**Commonwealth Edison**  
 Braidwood Nuclear Power Station  
 Route #1, Box 84  
 Braceville, Illinois 60407  
 Telephone 815/458-2801

April 25, 1994

Subject: Braidwood Station Unit 1  
 Request for EMERGENCY TECHNICAL SPECIFICATION AMENDMENT  
 Facility Operating License: NPF-72  
 Technical Specification 3/4.4.5  
NRC Docket No. 50-456

### DESCRIPTION AND SAFETY ANALYSIS OF PROPOSED CHANGES TO APPENDIX A TECHNICAL SPECIFICATIONS OF FACILITY OPERATING LICENSE NPF-72

FIGURE 1

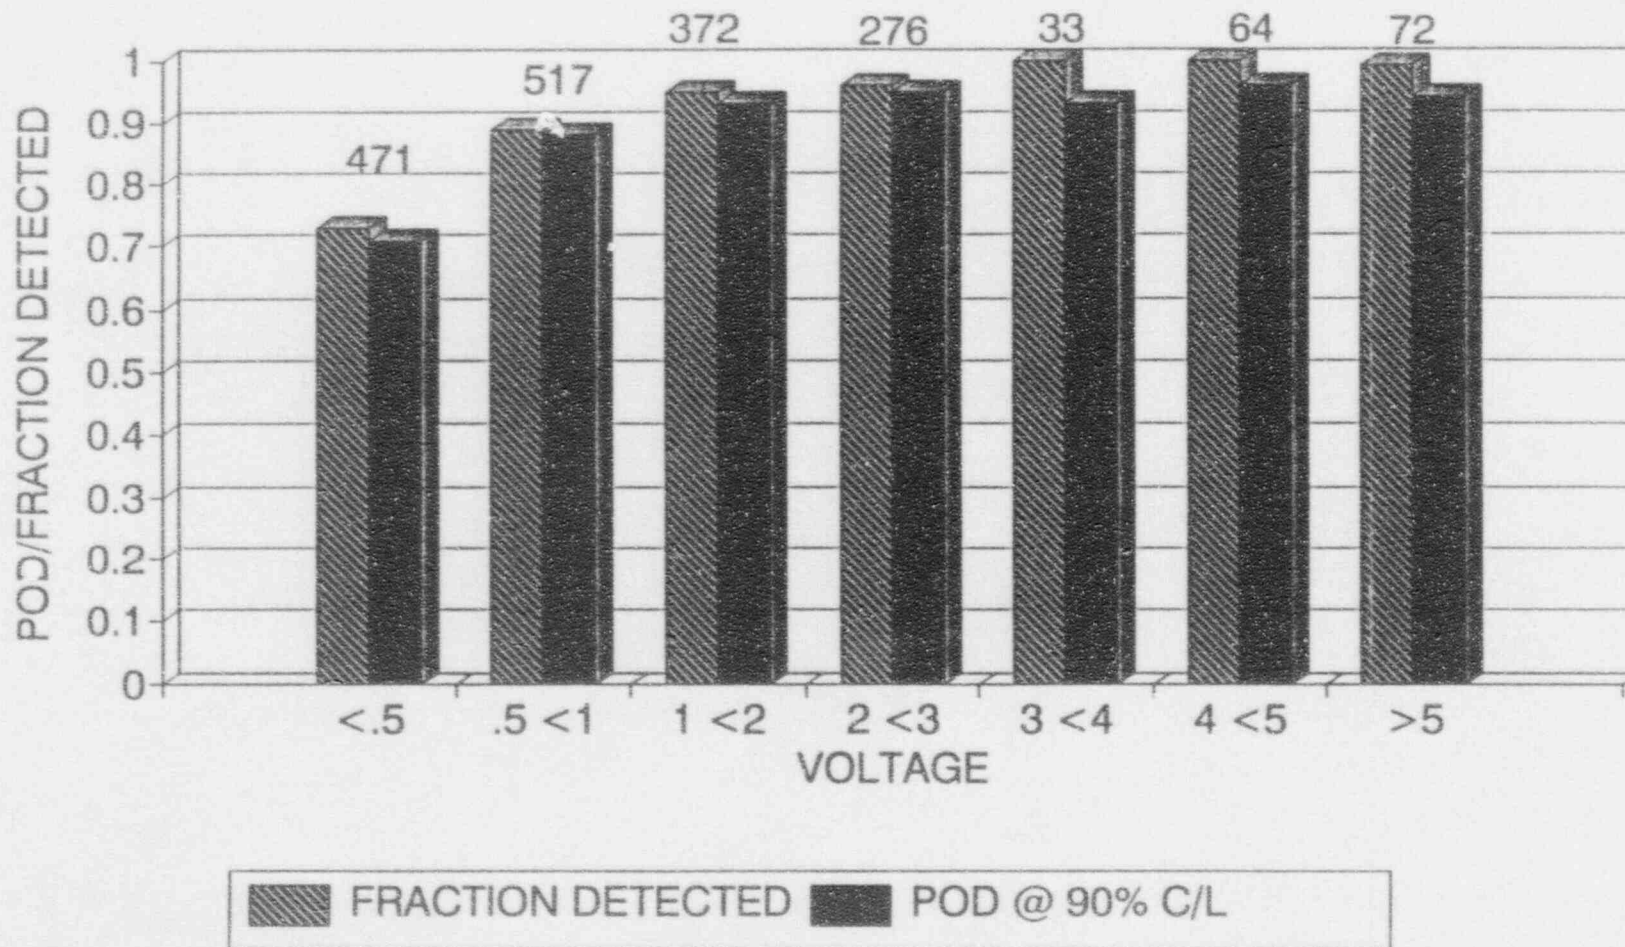
Based upon data collected as part of the EPRI Performance Demonstration Program (Refer to Figure 1) illustrates the performance of some 20 eddy current data analysts evaluating data from a unit with 3/4" inside diameter and 0.049" wall thickness tubes. This figure clearly demonstrates the voltage dependence of the POD and argues for a  $POD > 0.6$  for ODSCC indications larger than 1.0 volt.
